SEWAGE DISPOSAL SYSTEM
HOWARD COUNTY HEALTH DEPARTMENT
BUREAU OF ENVIRONMENTAL HEALTH
410-313-2640

SUBDIVISION Cattail Creek Country Club LOT NUMBER 13 ADDRESS 3645 Broadleaf Court

SITE PLAN
BROADLEAF COURT

DRIPLINE DISPOSAL DESIGN
 FOR
LOT 13 "CATTAIL CREEK COUNTRY CLUB"

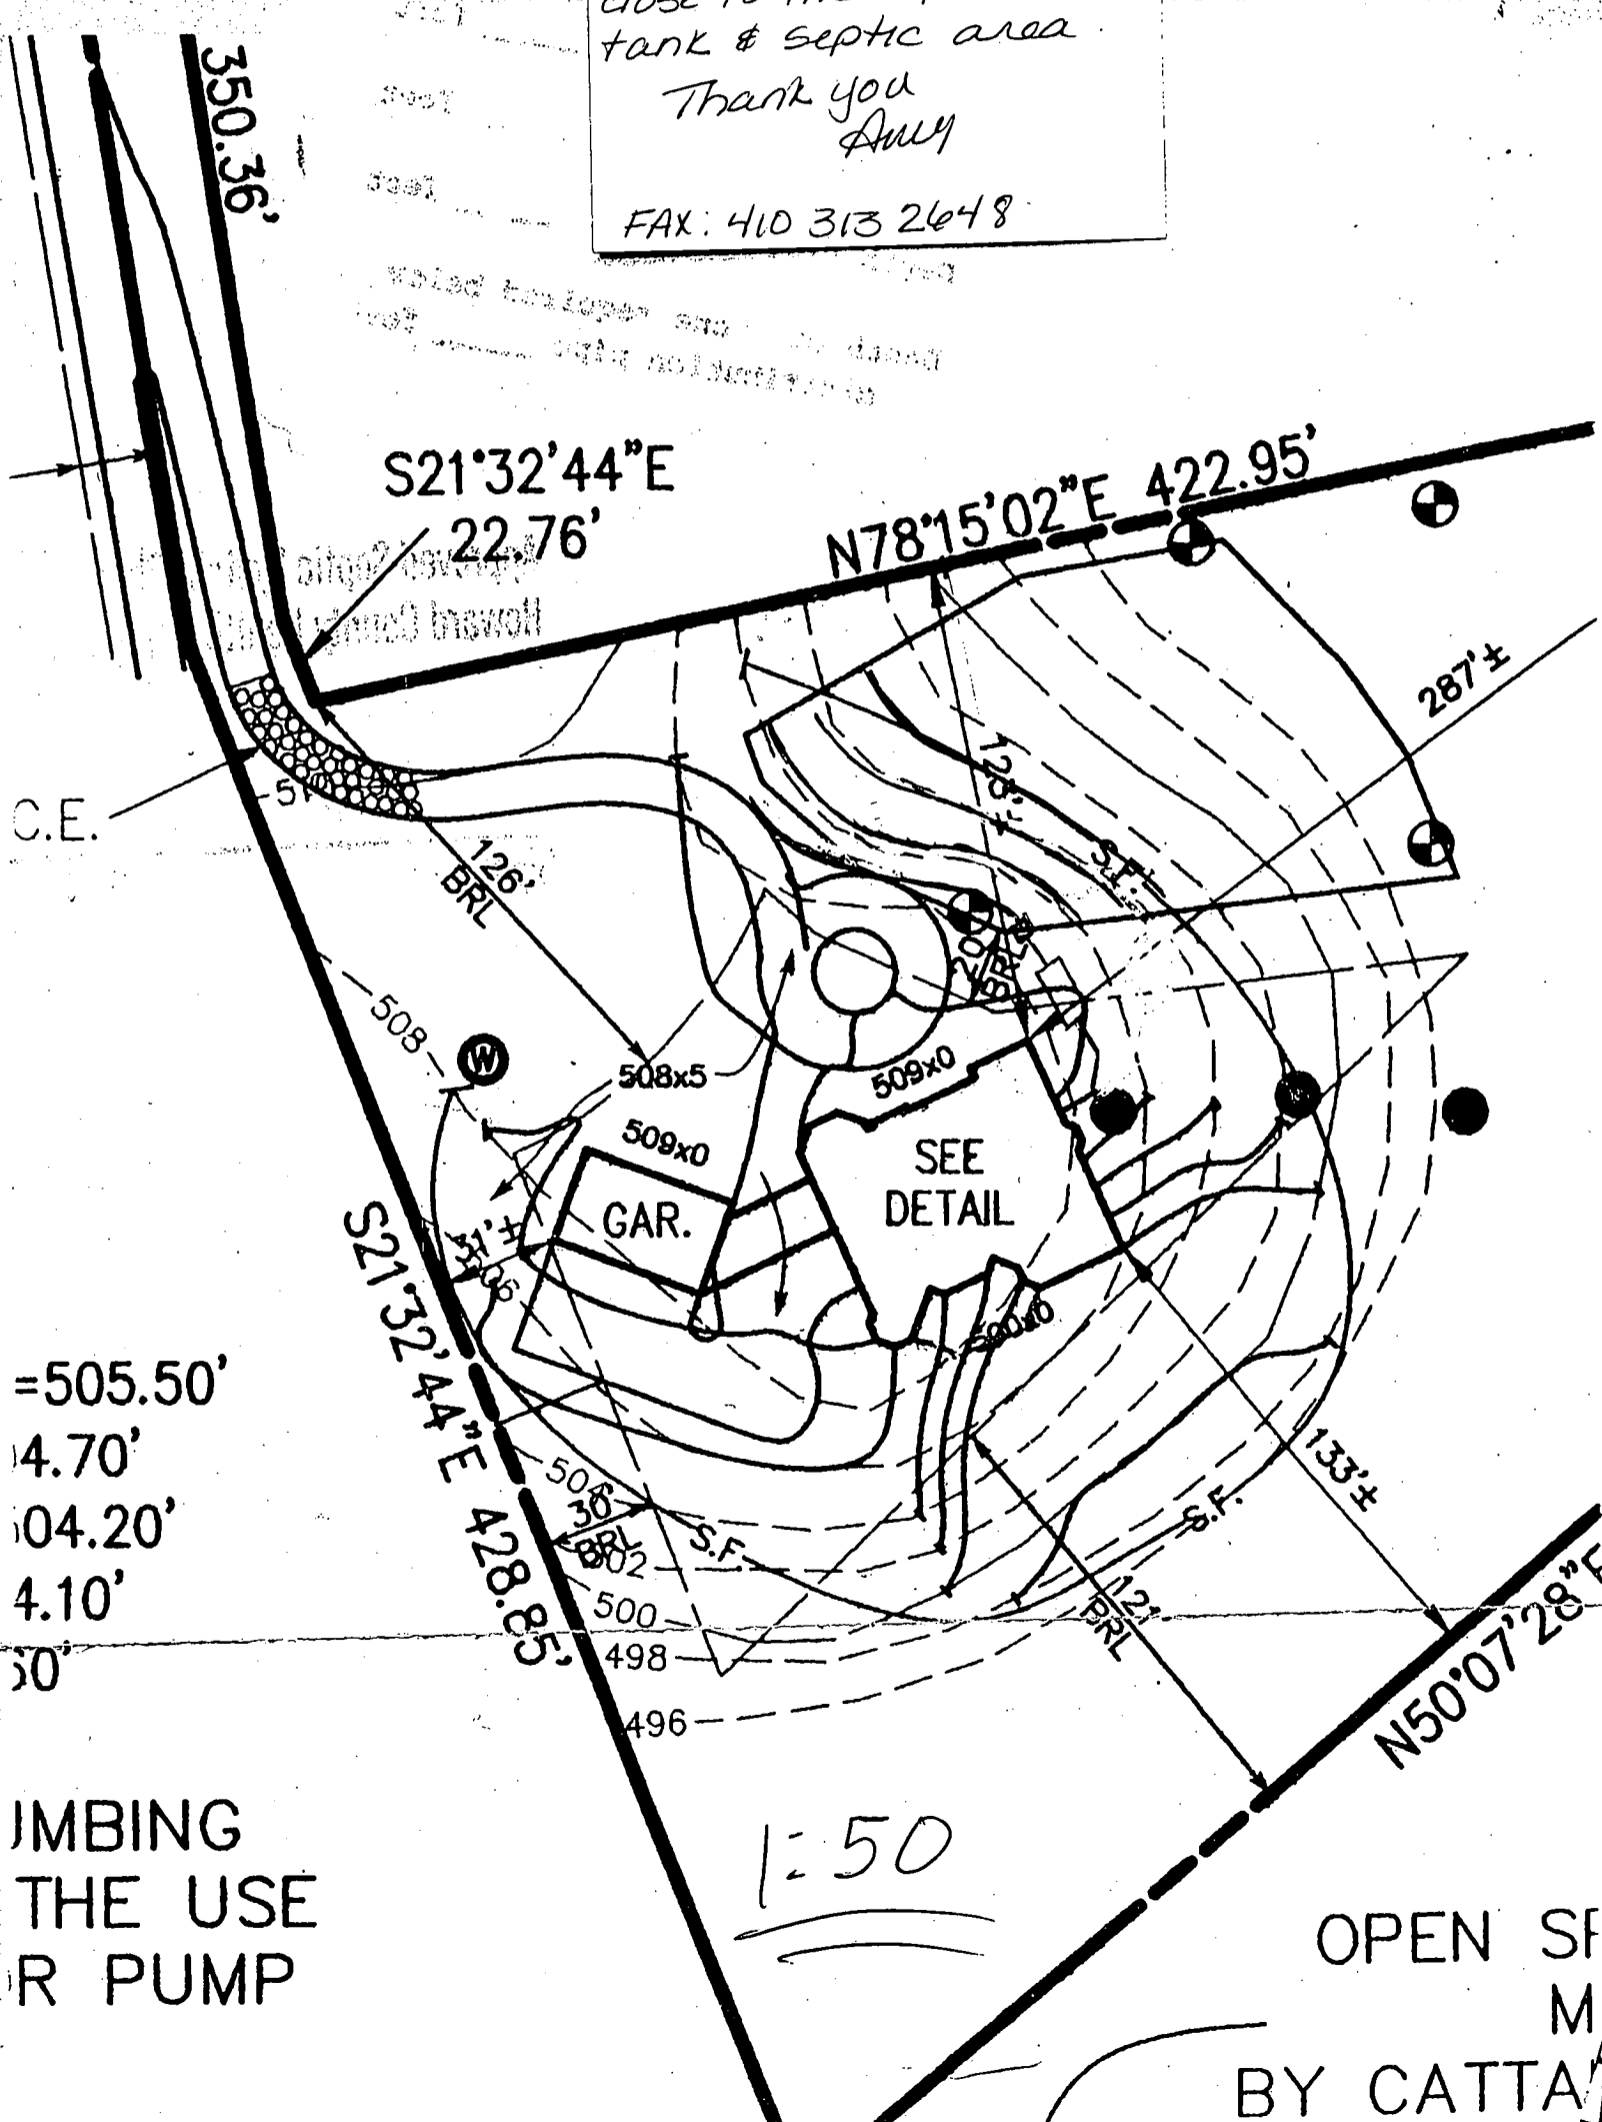
Please put propane tank location on this plan. The submitted plan appears to place the tank very close to the septic tank & septic area.

3/11/01
0001286006
Propane tank will be located 10' off the front left of house - no impact to well or septic.
A. McMillan

Amy - Tank location - Facing house -
left side - 10ft off the home
48ft from septic

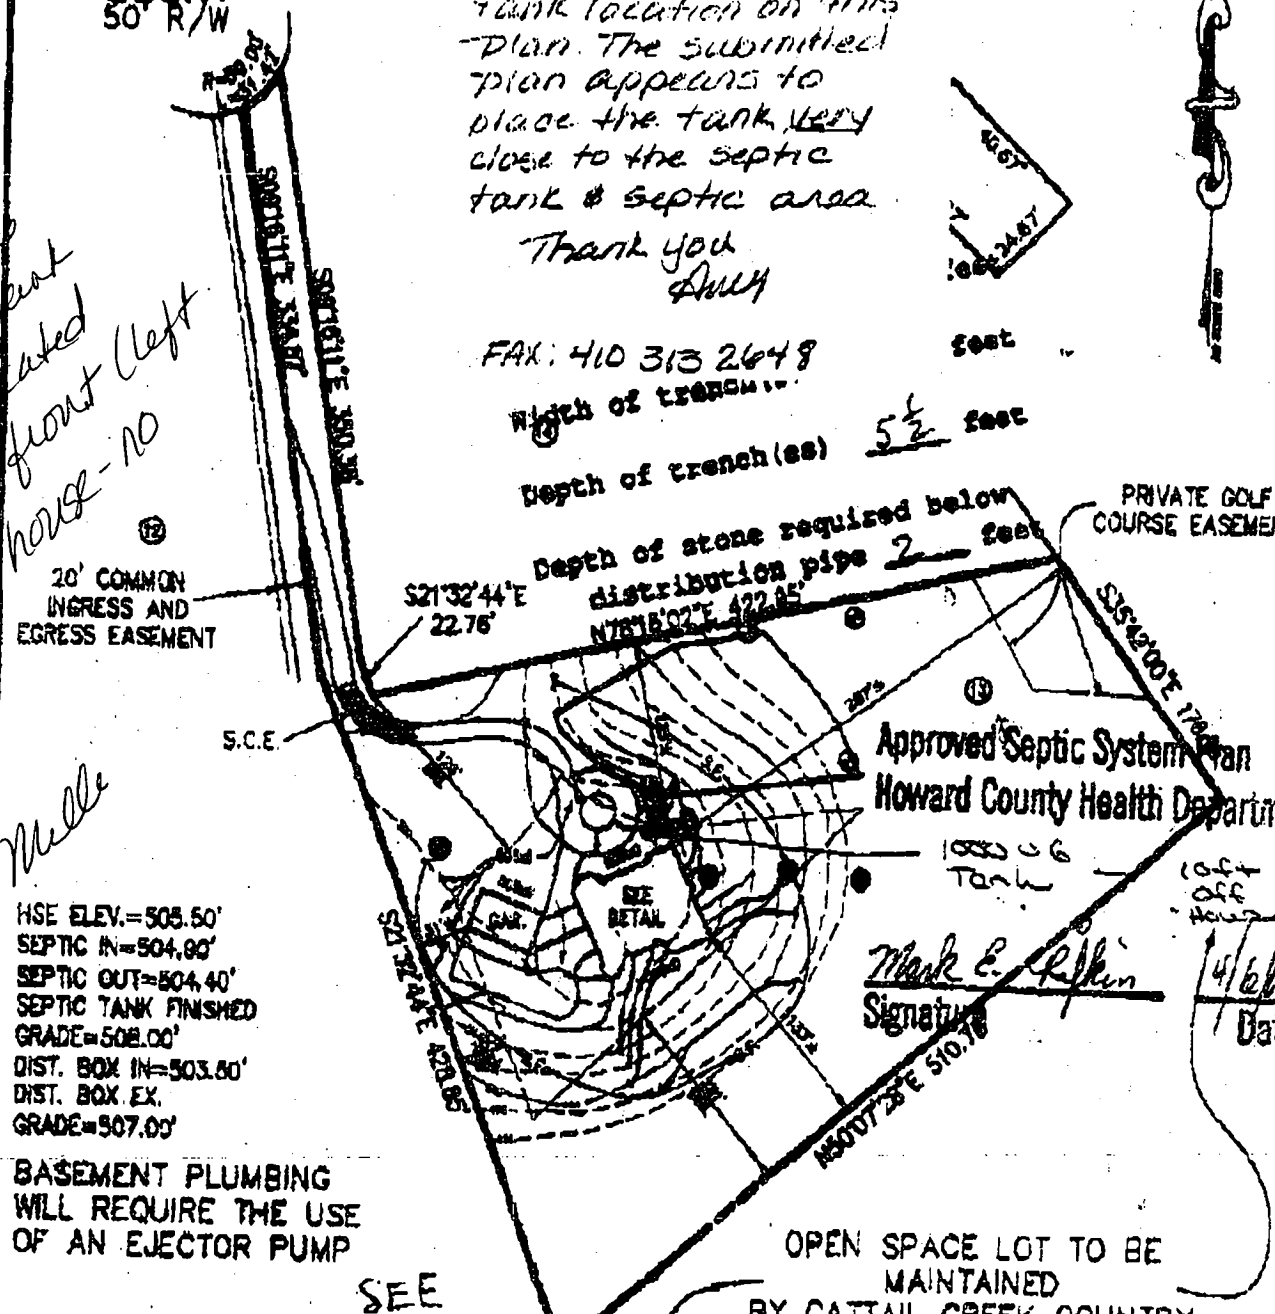
Please put propane tank location on this plan. The submitted plan appears to place the tank very close to the septic tank & septic area.
